Addendum No. 1

RE: Contract # C205160

Forsyth County (Project BR-0168)

BRIDGE #330289 OVER US-52 ON SR-4000.

SEAL

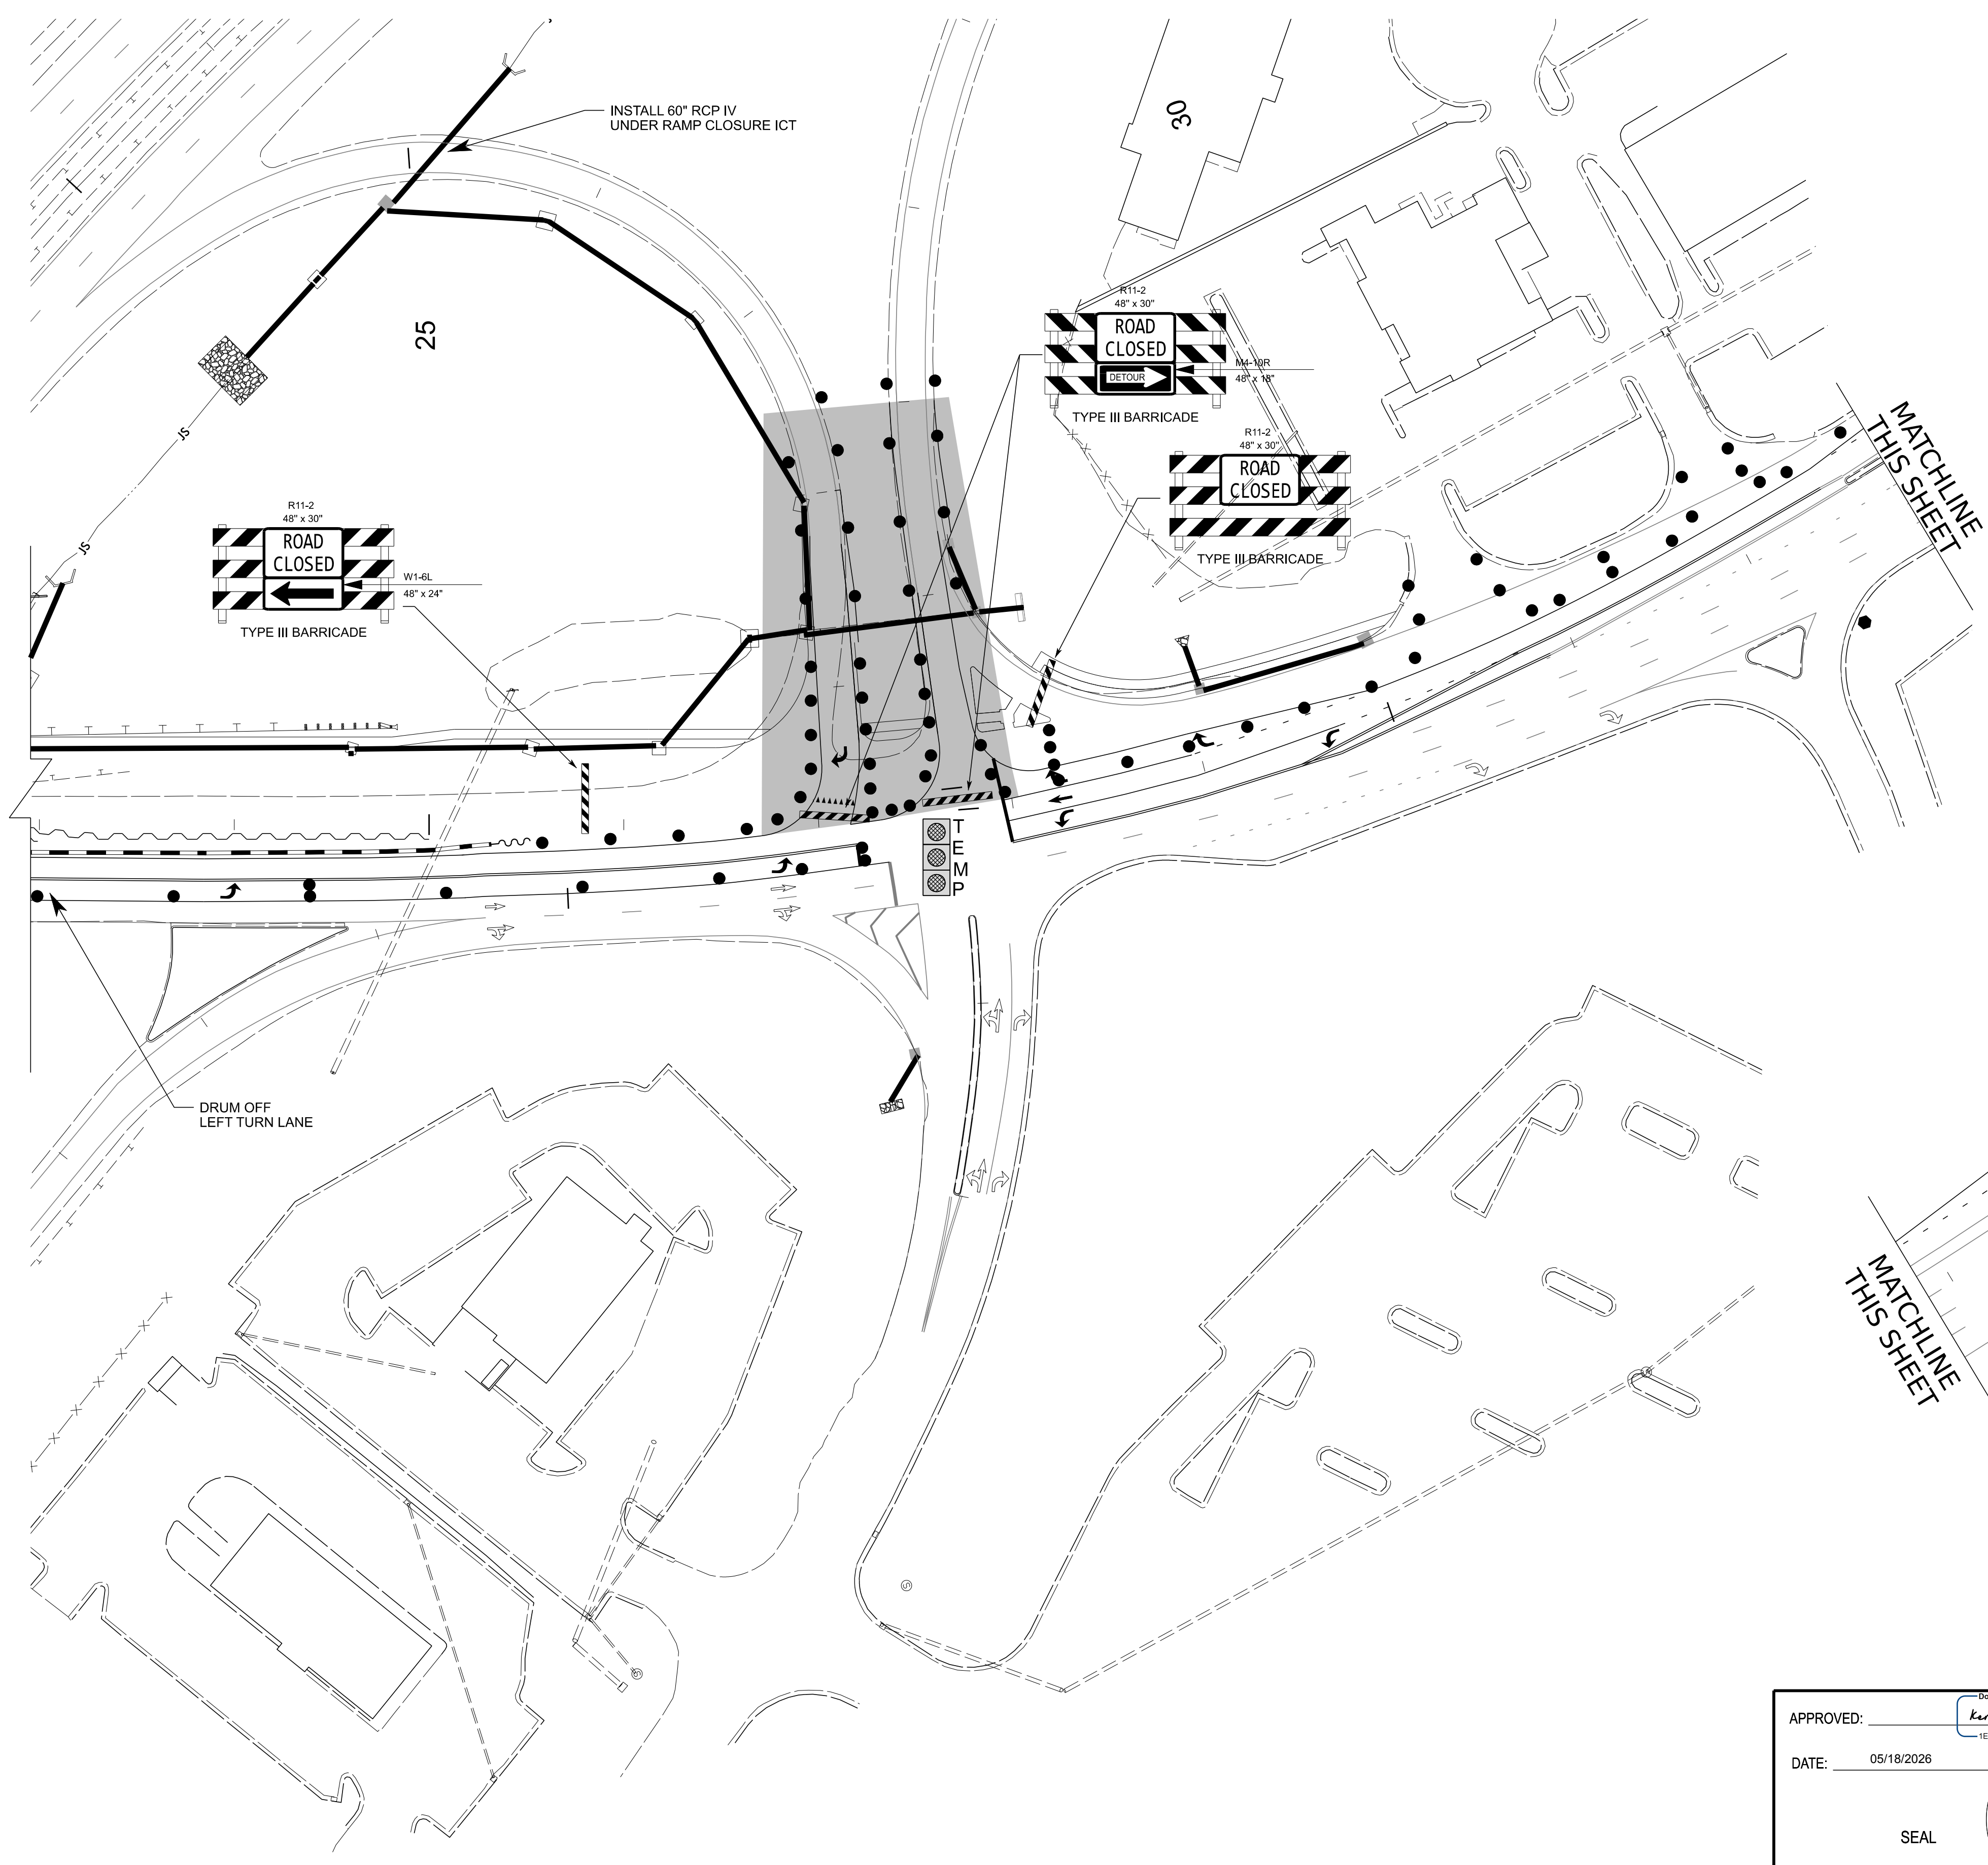
Sheet No.	Revision
TMP-3.4	Replaced with new sheet
TMP-3.5	Title block revised – match line corrected
TMP 3.6	Title block revised – match line corrected

GENERAL DRAWING
 FOR BRIDGE ON
 SR-4000/ UNIVERISTY PARKWAY
 OVER US 52

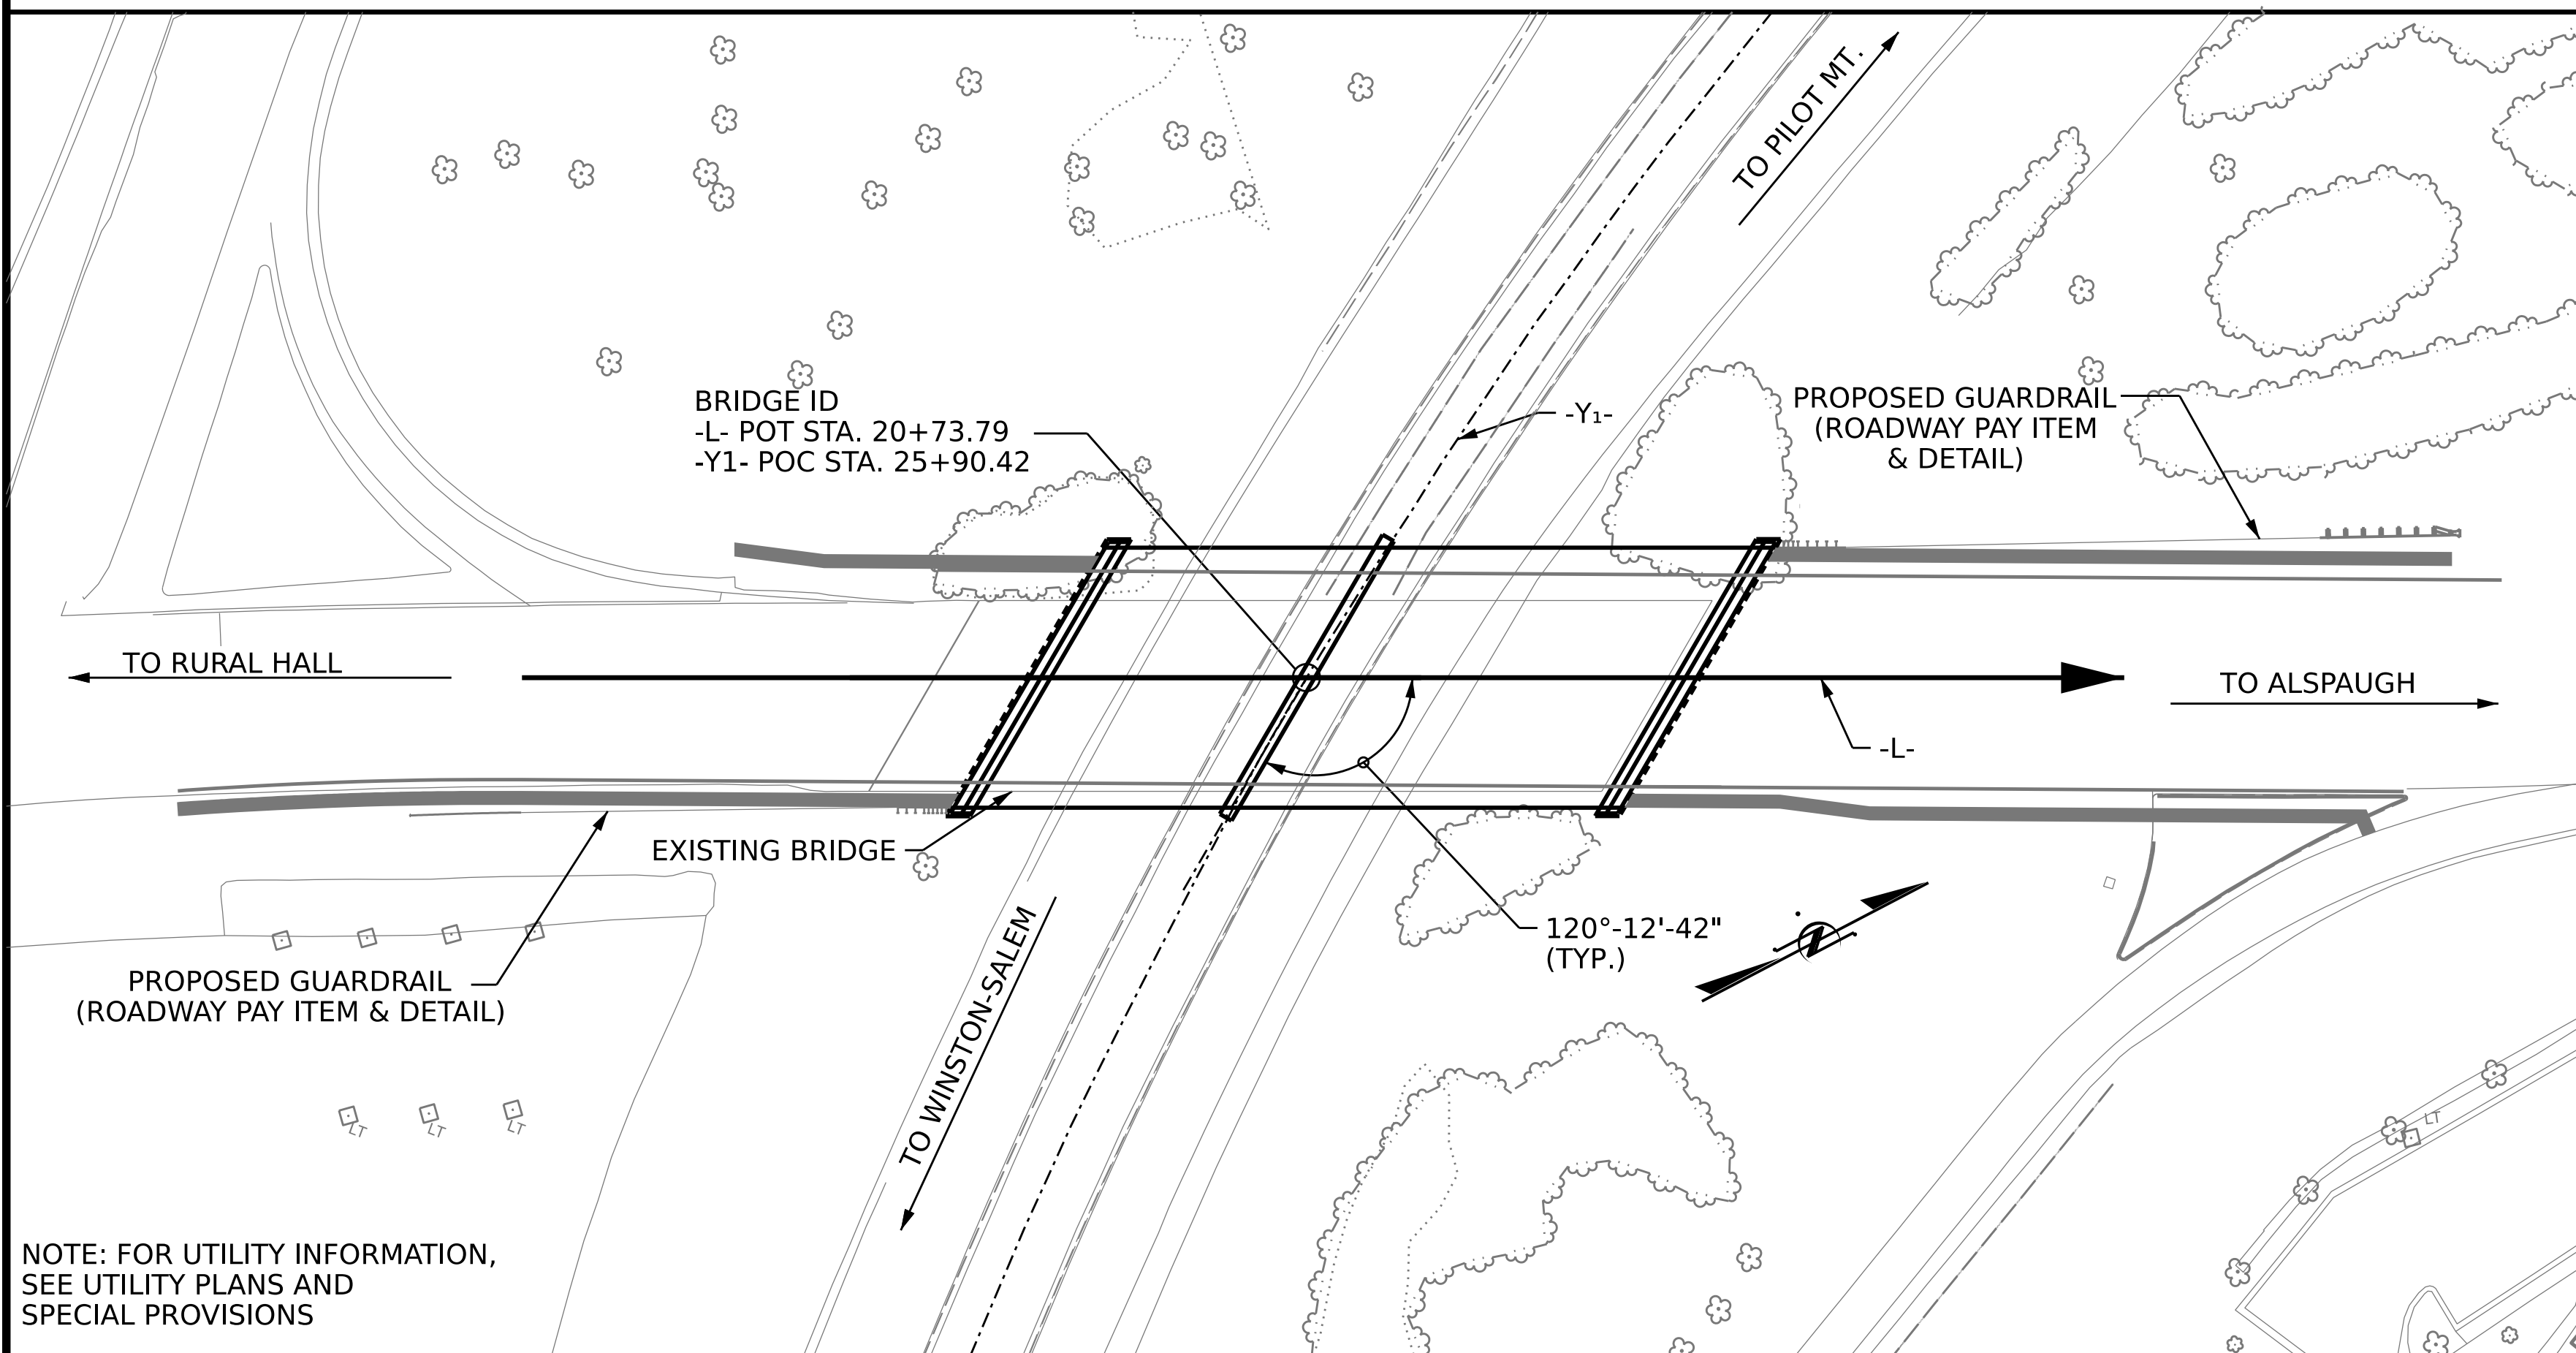
Sheet No.	Revision
1	Let date revised
S-05	General notes revised
